8580 RIVER DISTRICT CROSSING - "Parcel 18.1"
(COMPLETE APPLICATION)
DE418326 - ZONE CD-1

DEVELOPMENT PERMIT STAFF COMMITTEE MEMBERS

DEVELOPMENT PERMIT STAFF COMMITTEE RECOMMENDATION: APPROVE

DESIGN GRADES PLAN
SCALE 1:500

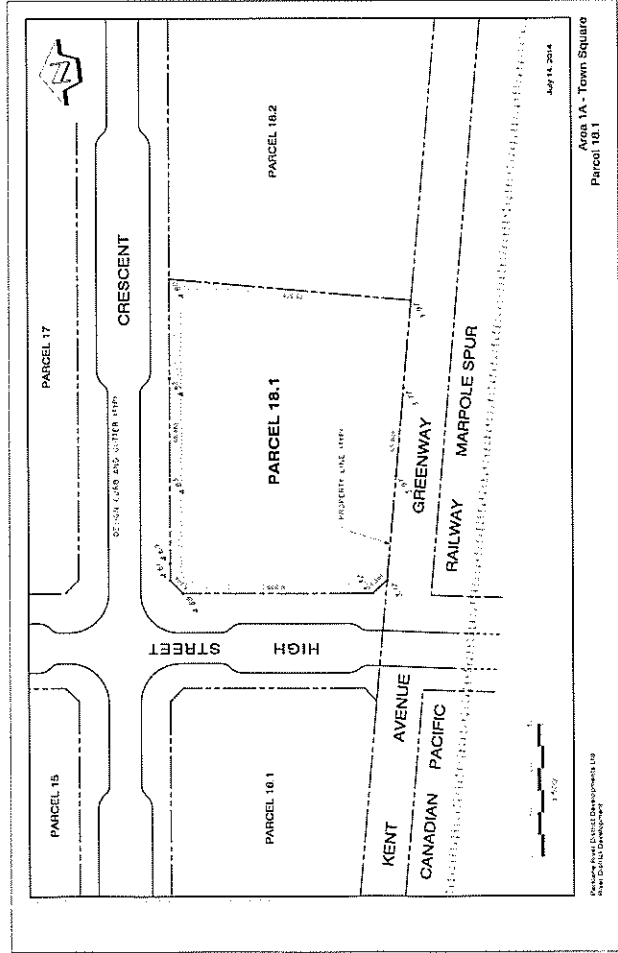
A.1.2 modifications to the height calculations and design grades as shown on drawing A1.0-H to coincide with the City building grades when they become available;

Note to Applicant: Provide a copy of the official City building grades plan. Elevations of the roof parapet are not consistent with the building elevations and site sections. Clarify the elevation of roof guardrail.
